**DEPARTMENT OF PUBLIC WORKS
AND ENVIRONMENTAL SERVICES**
Environmental and Facilities Review Division
12055 Government Center Parkway, Suite 535
Fairfax, Virginia 22035-5503
Telephone: 703-324-1720 Fax: 703-324-8359

Subject: Water Quality Impact Assessment for Thompson Road Assemblage, Plan #9820-
WQ-01-1, Tax Map #035-3-02-0000-B, 0000-C1, 0000-D1, 0000-E1, 0000-F1,
0000-G and 0000-M2, Sully District

Thompson Road Assemblage
Water Quality Impact Assessment
 February 18, 2004
 Plan Numbers: 9820-SD-02
 Tax Map Number: 035-3-02-B, C1, D2, E1, F1, G, and M2
 District: Sully
 WSSI #5433

Sheet #
1 of 4

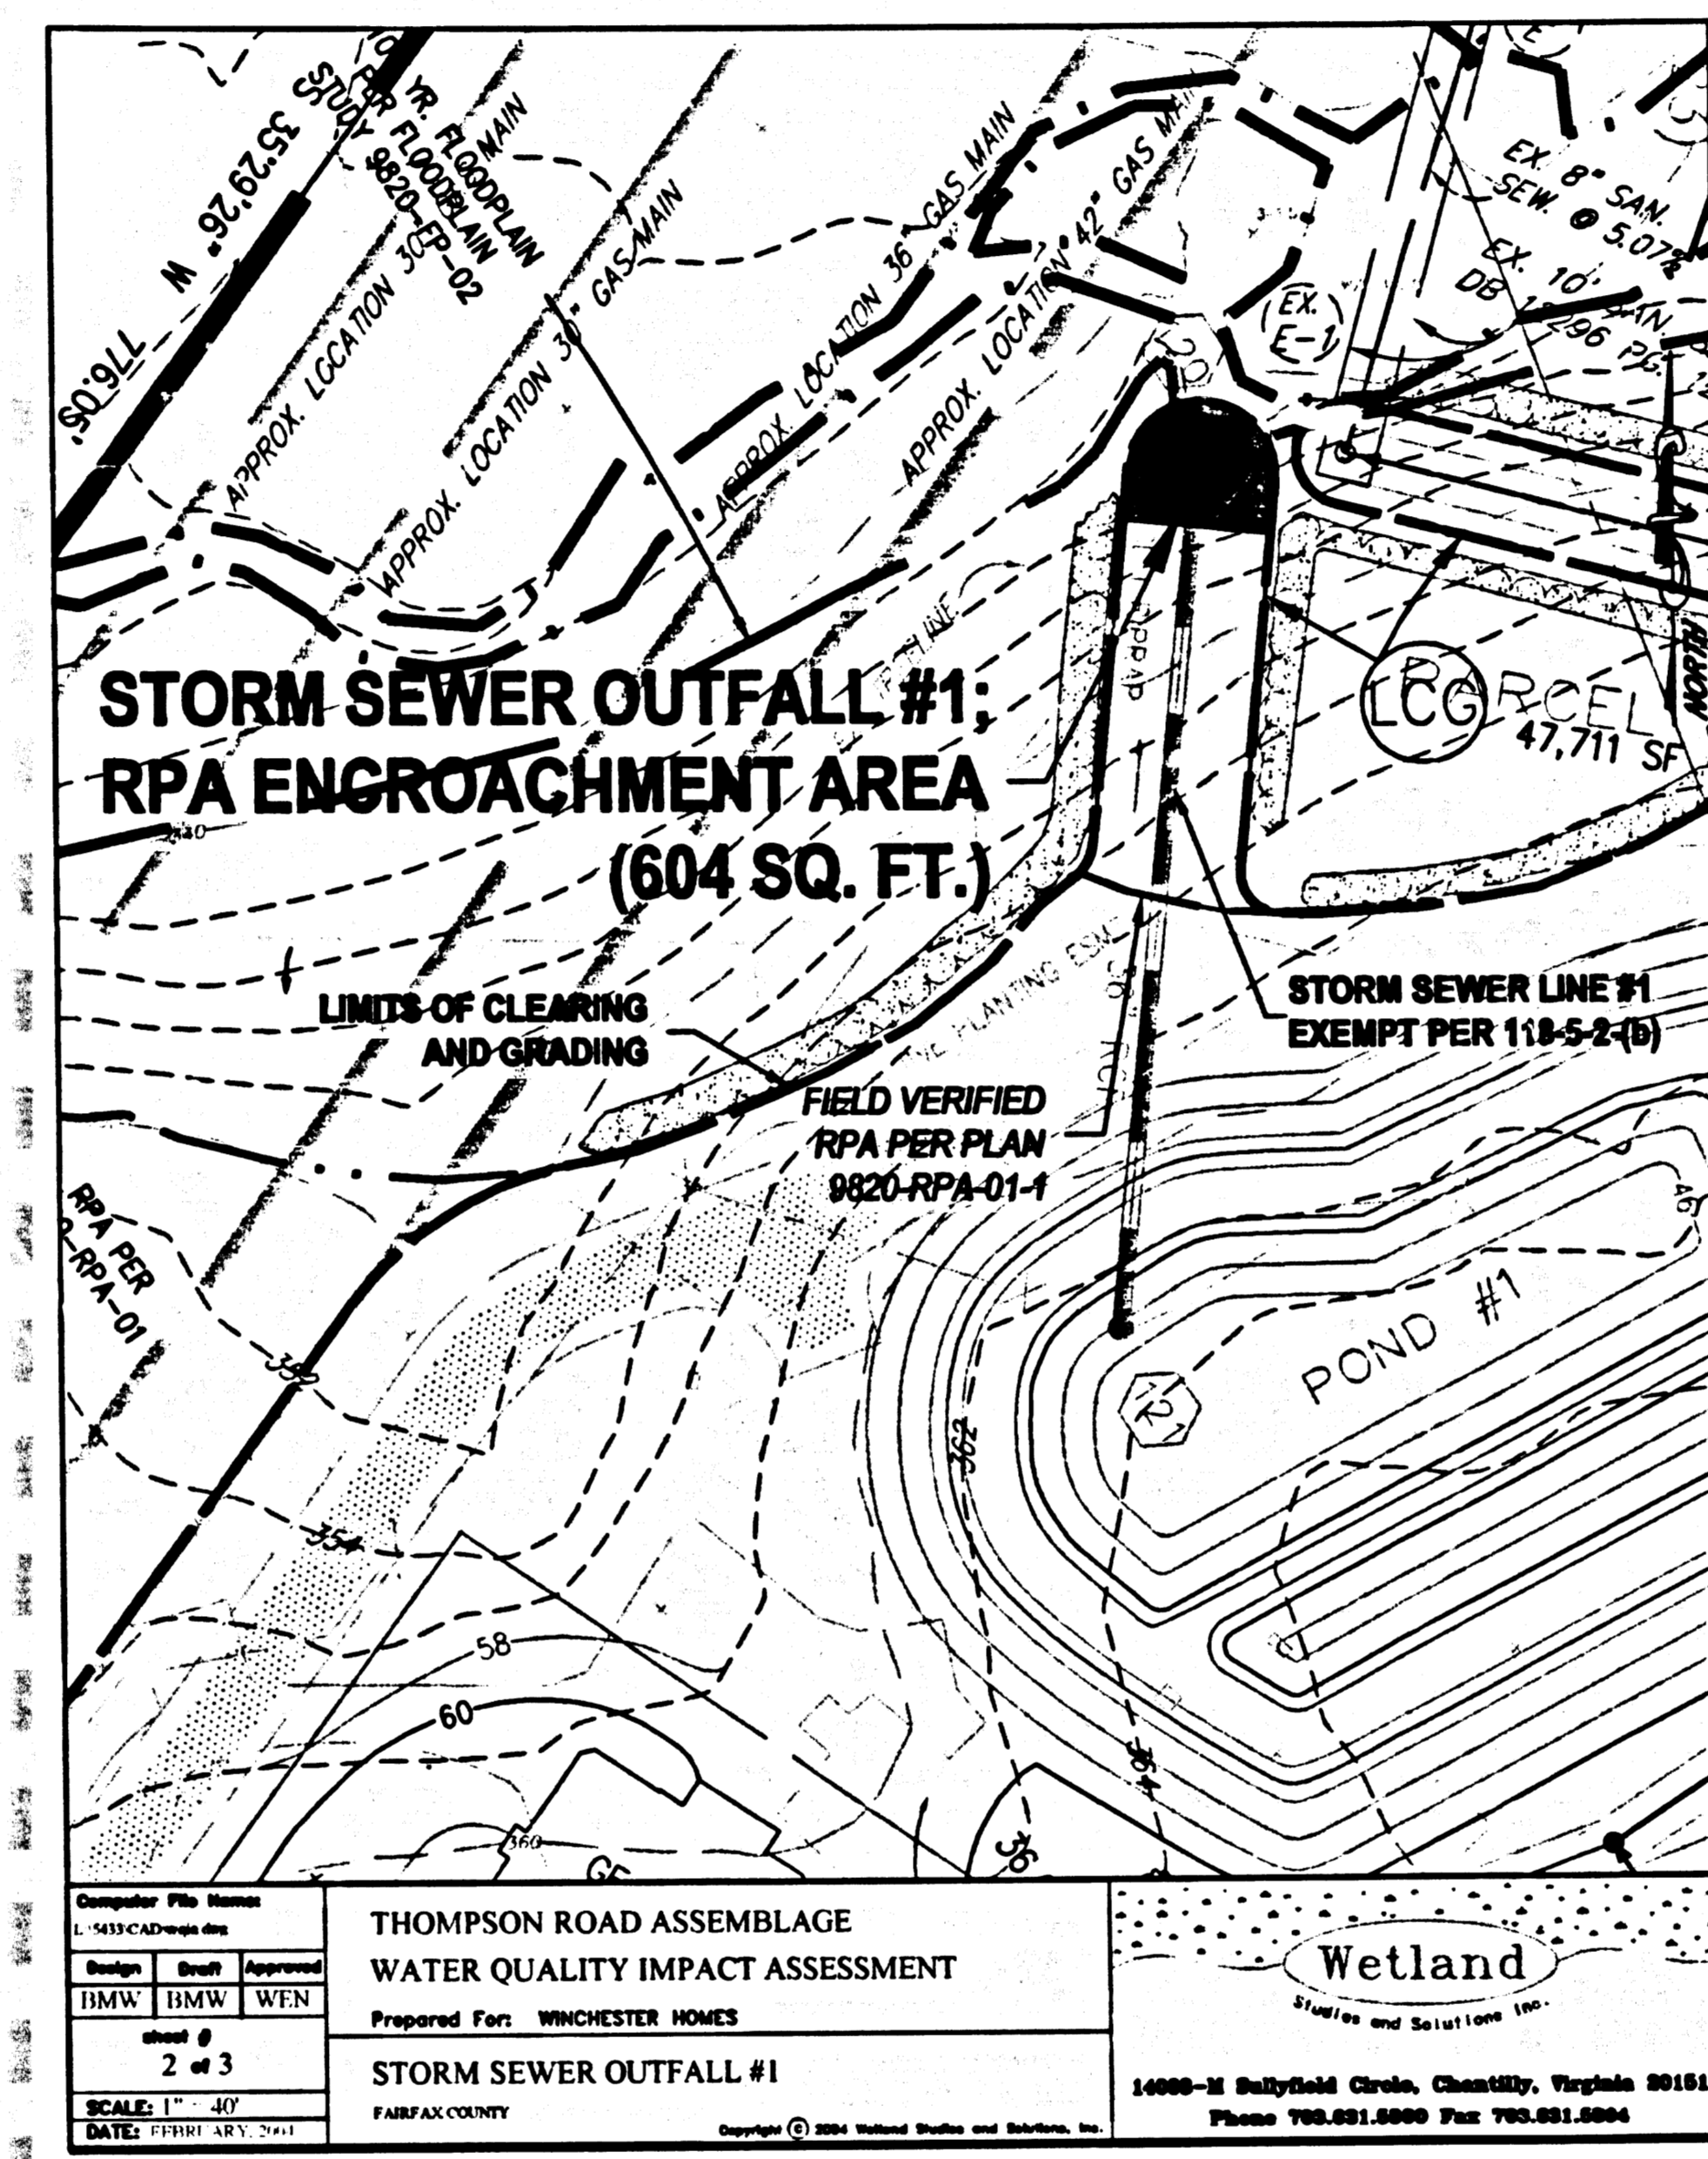
- The limits of clearing and grading for the proposed buildings at Lots #3400, 3405, 3409 and 3413 are very close to the Resource Protection Area (RPA) as depicted on Sheet 1 of 4. It is advised to relocate/move the proposed buildings so that no encroachment upon the RPA will occur.
- The limits of clearing and grading shown near and/or within the limits of the RPA must be strictly observed and enforced. Any encroachment into, and/or disturbance of the RPA not shown on this plan is considered a violation of the Chesapeake Bay Preservation Ordinance (CBPO) and is subject to penalties of the CBPO. This shall include but is not limited to the disturbance for purpose of construction of future decks or any other accessory structure at the backyards of all the impacted lots.
